Suggestion

ISO-Codes for FlexGTalpha

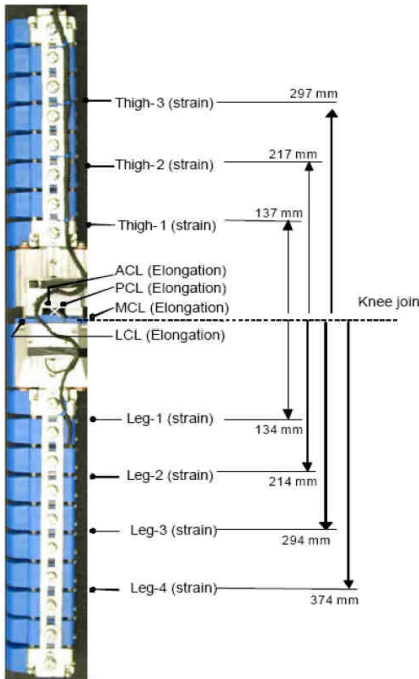
To clarify: Dummy coordinate system: Is the impact direction in X or Y axis?
 New Code Fine Location 3: "PG" for FlexGTalpha?
 New Code Fine Location 1: "MC" for Medial Collateral Ligament?
 New Code Fine Location 1: "LC" for Lateral Collateral Ligament?
 New Code Fine Location 1: "PC" for Posterior Cruciate Ligament?
 New Code Fine Location 1: "AC" for Anterior Cruciate Ligament?
 Further Channels / other locations planned?
